To: Public Works Contractors
From: Jennifer Skoglund, Airport Manager
Date: July 20, 2020
Re: Addendum No.1 to RFP
Project No. WWRA 2020-Sewer CIPP

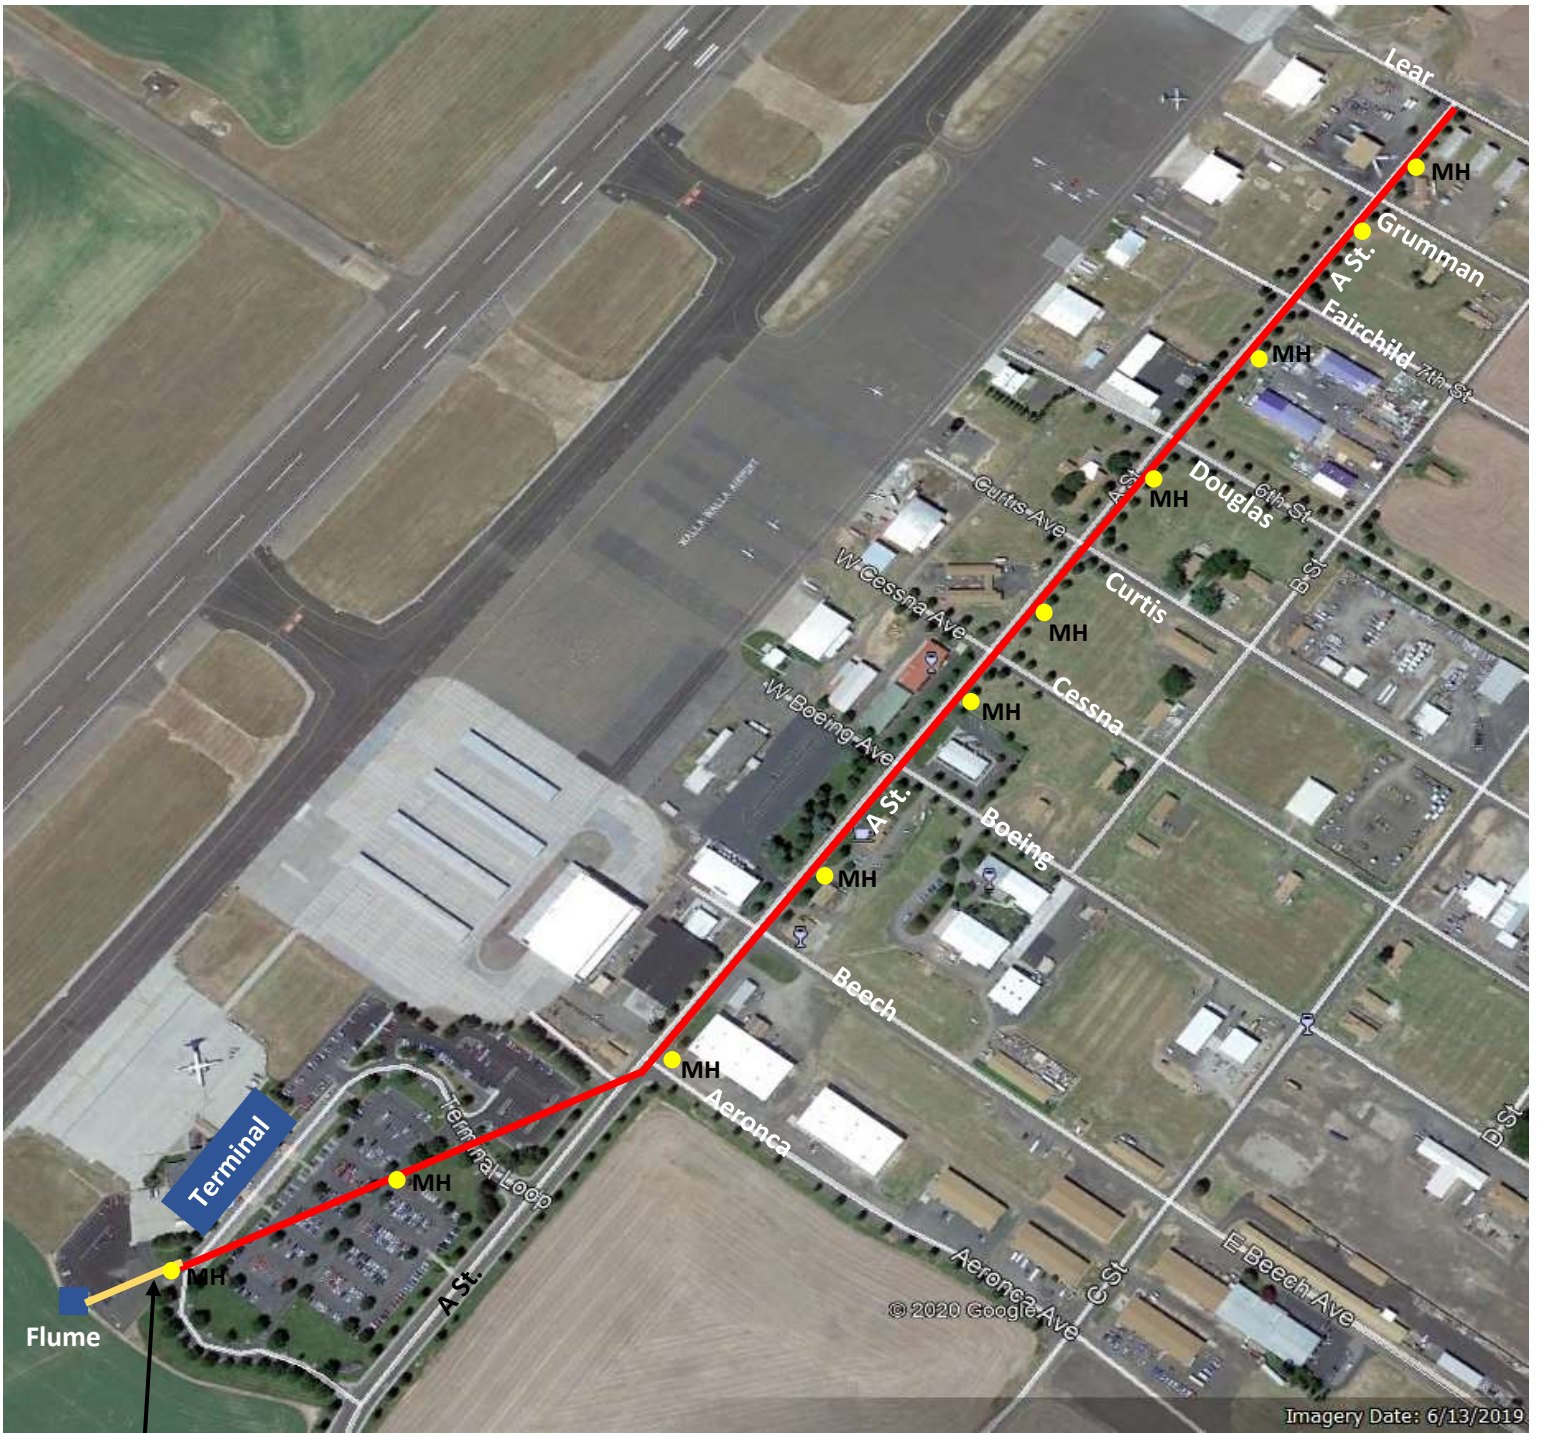
5. How many manholes are in the section of sewer line?
 - a. 10 manholes. See updated aerial diagram with manhole location.
